Product Change Notification

Date Issued :	May 19, 2022	PCN Number :	512042
Reason for Change :	Capacity change or tool replacement		
Description of Change :	This notice is to inform you that Molex Lincoln Nebraska is adding new capacity tooling. Tooling will be an exact replica of current tooling and there will be no change to product when compared to current tooling.		
Reason for Short Notice :	Capacity Increase		
Assessment of Change :	First Article Inspection		
Planned Implementation Date :	July 08, 2022		
Sample Availability Date:	June 10, 2022		
Internal Molex Qualification Date :	June 24, 2022		
Last date to request Samples by Customer :	June 30, 2022		
Traceability Code Markings / Date :	Product made after planned implementation date can contain the change

- **5557 Series**
 - Mini-Fit Jr. Receptacle Housing

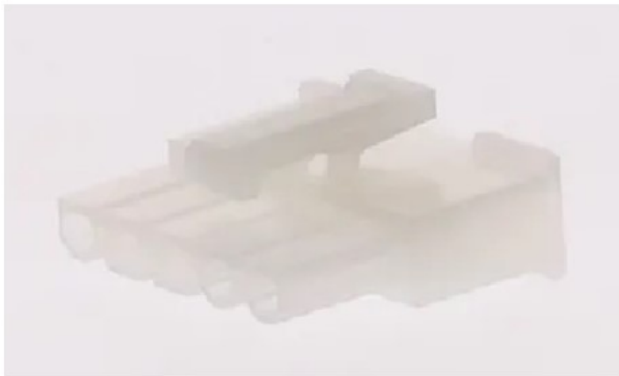
- To ensure business continuity, another set of tooling is being added
 - New tooling will be an exact replica of current tooling
 - Tooling being added to keep up with current and future demand
 - Tooling only being added to Molex Lincoln Nebraska location

- There is NO impact to Fit, Form or Function
